Field campaign

Topic	Fatigue warning not visible Bentayga Series 24MY (SC24/20)
Market area	United States E05 Bentley USA and rest America (6E05)
Brand	Bentley
Transaction No.	2074877/2
Campaign number	ED13
Note	
Type	
US code

Revision history – TPI 2074877/2

Work section has been revised with further instructions added on how to rectify fault with the fatigue warning.

Figure 1

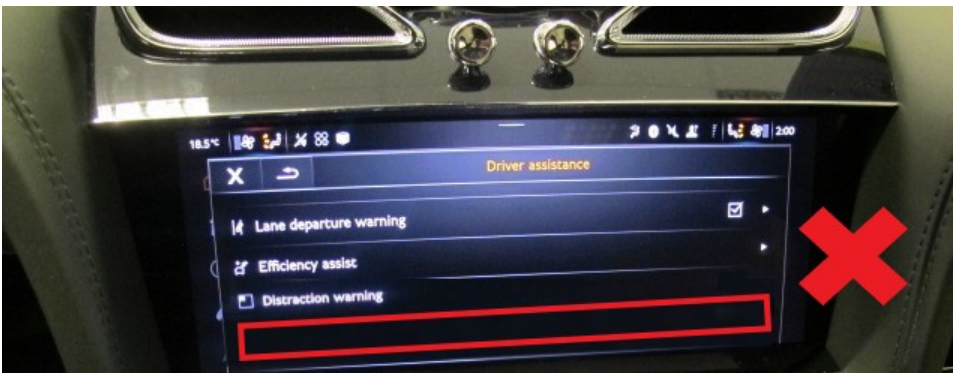
Fatigue warning is not visible (Figure 1) within the Infotainment screen menu after replacement of the Data bus control unit (J533)

- Once the procedure is complete check the infotainment screen to confirm if the "Fatigue warning" menu entry is displayed and can be selected under the Driver assistance menu as Figure 1

Figure 2

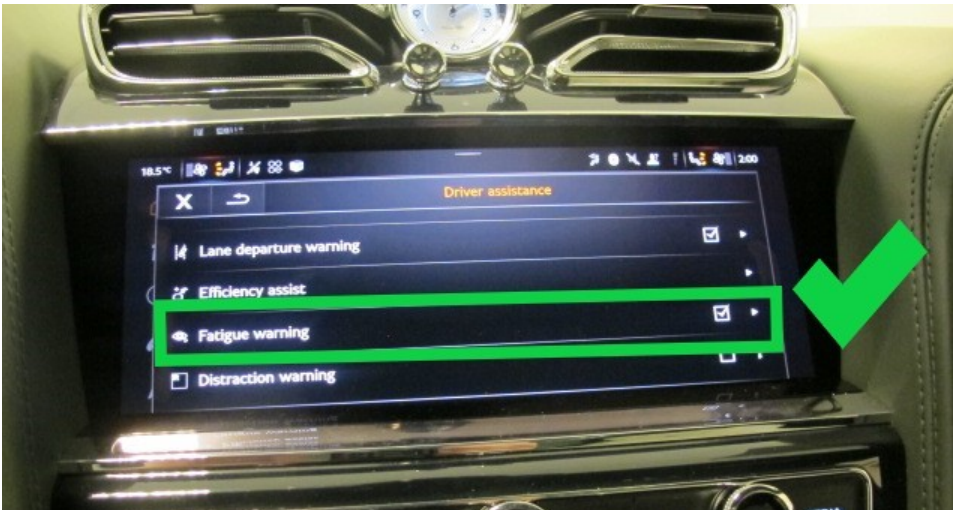
NOTICE
 Figure 2 shows the Fatigue warning (Correct status)

Figure 3

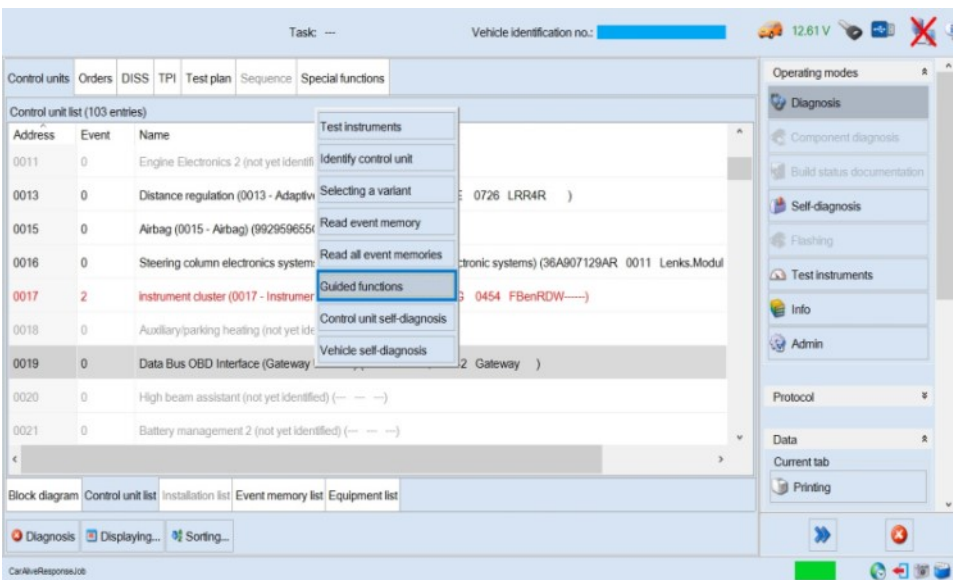
- Connect a suitable 12 volt battery charger to the vehicle before proceeding - Refer to Rep.Gr 27
- Select Guided functions from 0019 Data Bus OBD interface (Gateway) Control module (Figure 3)

- Select Guided functions from 0019 Data Bus OBD interface (Gateway) Control module (Figure 3)
- Referring to Figure 4 - Select 0019 – replace control unit > Select Run

Figure 4

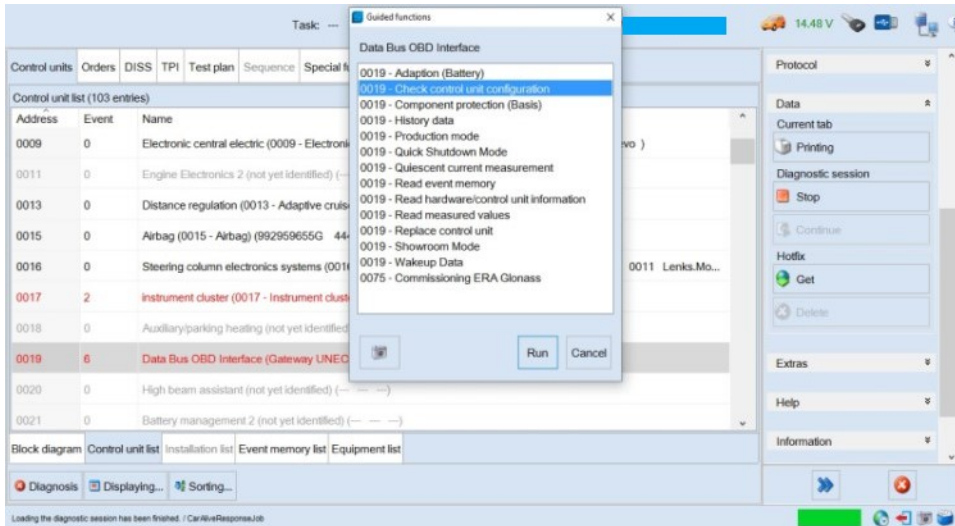
Referring to Figure 4 - Select 0019 - Check control unit configuration > Select Run
